United States Department of the Interior

3482, U-79975, UTU-81893
U-66060, SL-027304, U69600
U-010581, UTU-8193,
(UT-923)

RE: Approval of a Minor Modification to the Resource Recovery and Protection Plan (R2P2),
Ventilation and North Area Mine Plan Changes, Aberdeen Mine

Mine Plan Map (two parts) - portions are approved as stated in this letter

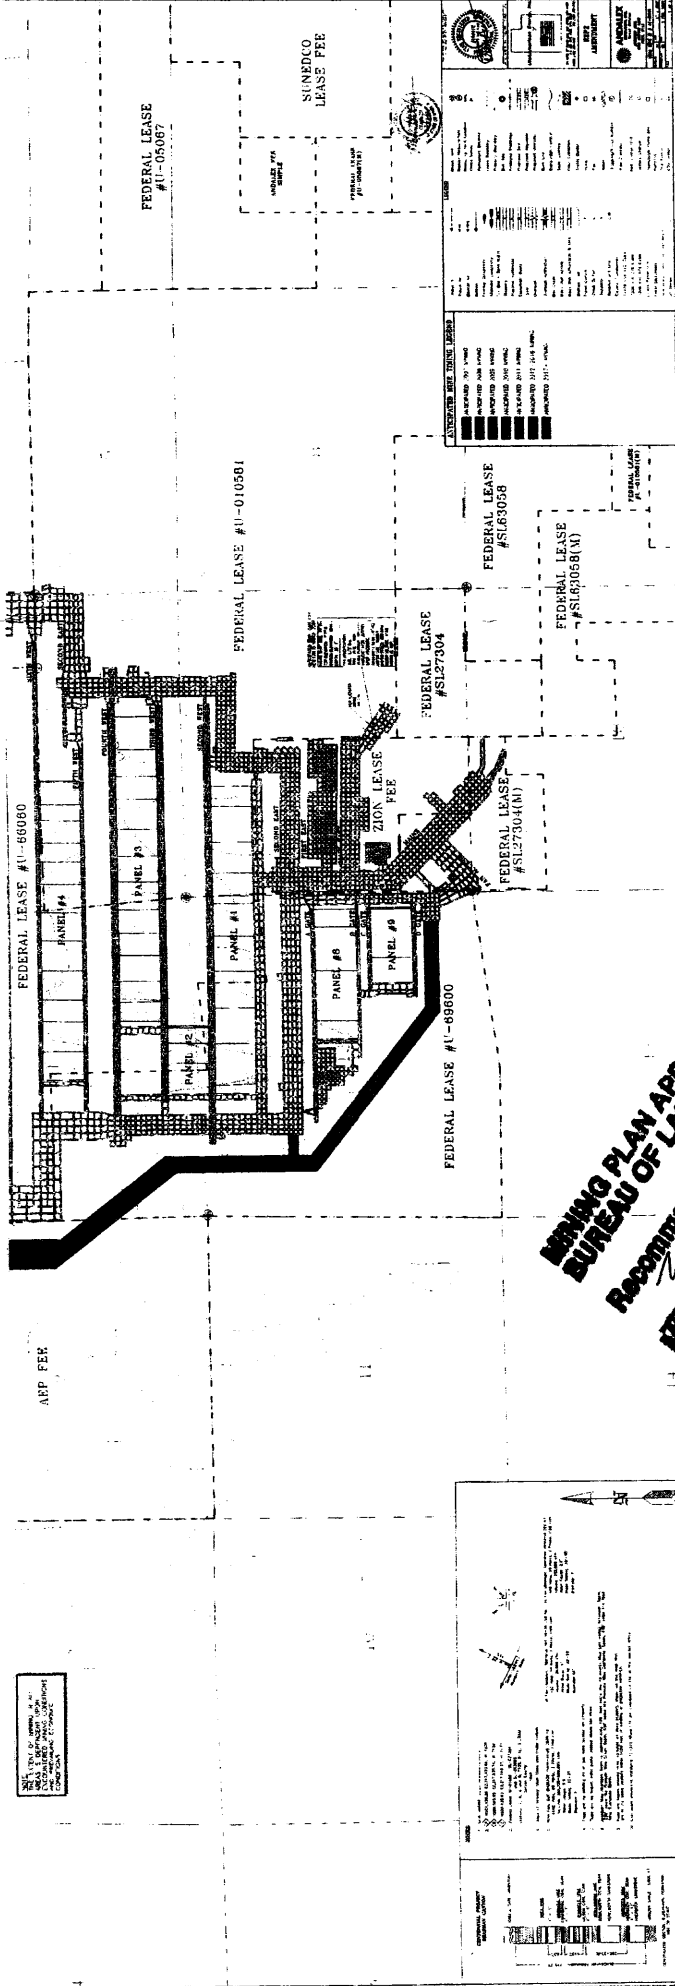
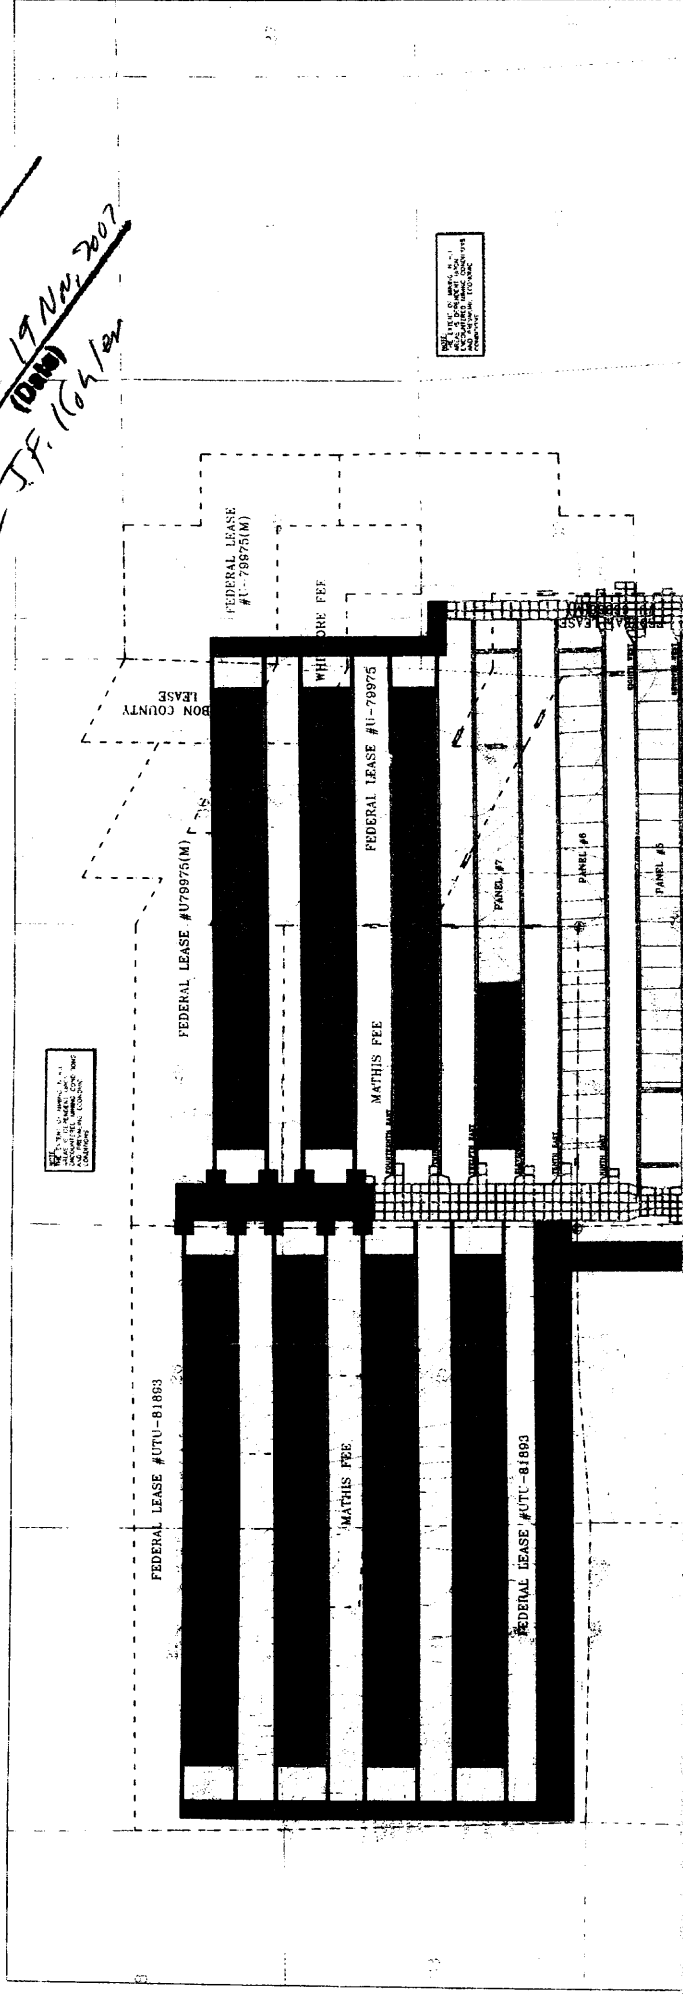
Approved: The BLM has evaluated the proposals and documents our findings. The R2P2 modification submittal letter from UEI has multiple requests, some of which can be approved, and some of which cannot be approved through this letter. The BLM approves the following elements of the subject R2P2 modification request. This approval is provided by BLM only; all other approvals by other entities and agencies are not part of this approval. A copy of the mine map that includes the approved items is included.
